**BEFORE THE BOARD OF PATENT APPEALS
AND INTERFERENCES**

Application Number: 09/945,006
Filing Date: August 31, 2001
Appellant(s): EVANS ET AL.

EXAMINER'S ANSWER

FIG 14: BONES OF THE FOOT

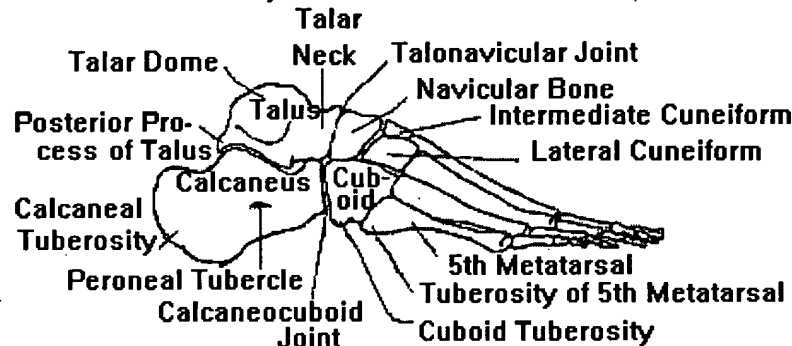
Appellant argues that Schroer, Jr. et al. does not teach the relationship between the elements of claim 2. This determination from Schroer, Jr. et al. is made with respect to the knowledge that one of ordinary skill in the art is aware of where the bones of the foot are located. Knowing this and looking at the Figures of Schroer, Jr. et al., one can clearly see the relationship between the bones of the foot and the innersole of Schroer, Jr. et al. (especially Figures 1 and 3. Figure 3 shows the relationship of the innersole with respect to a user's foot whereas Figure 1 shows how far and where the support is located across the width of the innersole.). With respect to appellant's arguments about metatarsal support, this support can clearly be seen especially with the knowledge of foot structure that one of ordinary skill in the art would have (see 3 page attachment for location of metatarsals and compare with figures 1 and 3 of Schroer, Jr. et al.).

Appellant argues that claim 3 is patentable over Schroer, Jr. et al. does not teach the relationship between the elements of claim 3 and the human foot, especially a curve extending across a point generally corresponding to a cuboid of the foot as it extends posterior of the Astragalus (Talus). This is clearly shown when comparing Figures 1 and 3 with the 3-page attachment of common knowledge of location of the bones of the foot.

Arguments 4-13 further argue that particular locations of the sole of Schroer, Jr. et al. do not lie where claimed in the claims. These locations can clearly be seen with respect to Figures 1 and 3 and the common knowledge of the bones of the foot by one of ordinary skill in the art and as shown in the 3-page attachment. For reference to Tibialis Anticus, this would be the muscle running from the tibia to the first metatarsal and cuneiform bones.
